AMENDMENT OF SOLICITATION/MODIFICATION OF CONTRACT				1. CONTRACT ID CODE		PAGE OF PAGES 1 6	
2. AMENDMENT/MODIFICATION NO. 0006		3. EFFECTIVE DATE 16-Jul-2003		4. REQUISITION/PURCHASE REQ. NO. 37170091		5. PROJECT NO.(If applicable)

14. DESCRIPTION OF AMENDMENT/MODIFICATION (Organized by UCF section headings, including solicitation/contract subject matter where feasible.) Answer contractor questions							
Except as provided herein, all terms and conditions of the document referenced in Item 9A or 10A, as heretofore changed, remains unchanged and in full force and effect.							
15A. NAME AND TITLE OF SIGNER (Type or print)				16A. NAME AND TITLE OF CONTRACTING OFFICER (Type or print)			
15B. CONTRACTOR/OFFEROR		15C. DATE SIGNED		16B. UNITED STATES OF AMERICA		16C. DATE SIGNED	
_____ (Signature of person authorized to sign)				BY _____ (Signature of Contracting Officer)		16-Jul-2003

1. The following paragraphs provide additional contractor questions regarding the solicitation and the Government's answers to the questions:

Figure 3-4. Seawater System Tubing Schematic

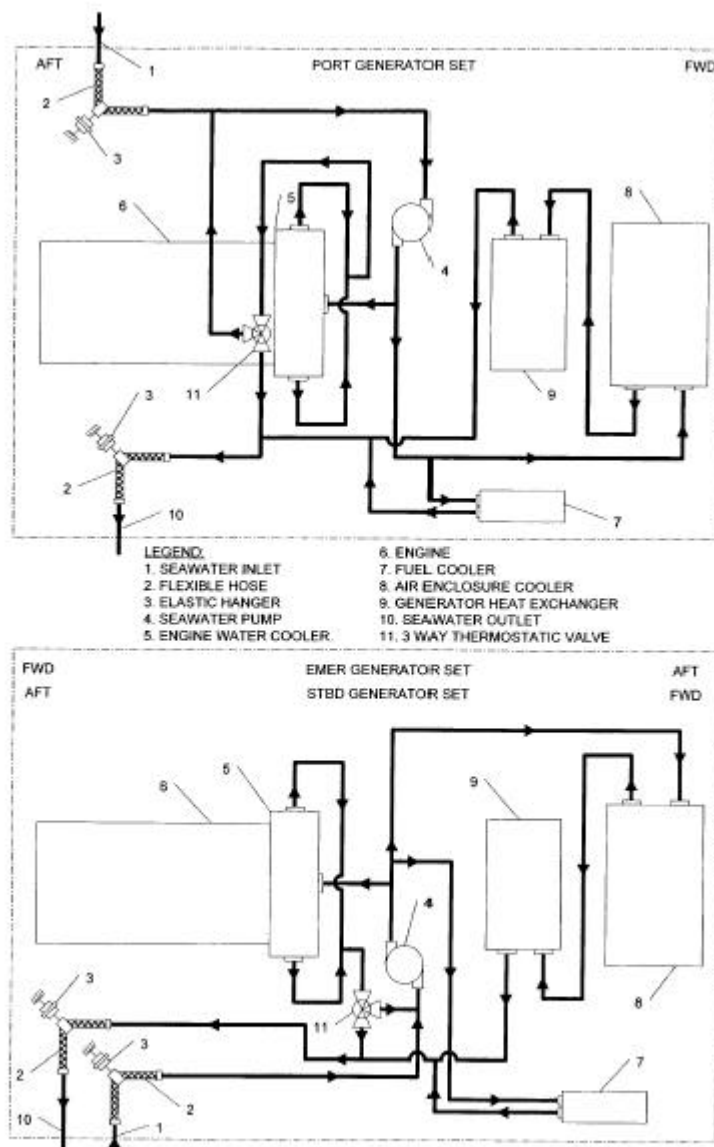
For us to analyze any potential impact, we need to understand the interaction between the components listed, Generator, reduction gear, IFVG, Fuel cooler and Enclosure cooler and the engine cooling system. Please advise the interaction of these components and the engine cooling system. Is cooling water for the components listed expected to be in the same cooling circuit as the engine? We assume that gear oil coolers, generator cooler and other components listed obtain and discharge their cooling water separate from the engine. Please clarify.

MHC SSDG Seawater System Description. (Figure 3-4) Seawater to the enclosure penetration point is provided by the ships auxiliary machinery seawater cooling system. From here, it is piped to the suction side of the engine driven

seawater pump. This pump discharges to the engine water cooler, enclosure air cooler, and the fuel cooler. Seawater discharged from the water cooler is monitored in a thermostatic valve. The valve ports hot seawater overboard or partially re-circulates cool water to the pump suction until the water temperature rises above the valve's full opening range. If valves fail to operate automatically, use the manual override to send salt water overboard. Seawater leaving the air cooler passes through the generator air cooler before joining the outlet from the enclosure. All seawater piping within the enclosure is of rigid copper-nickel construction and is resiliently anchored. A seawater low pressure alarm is provided.
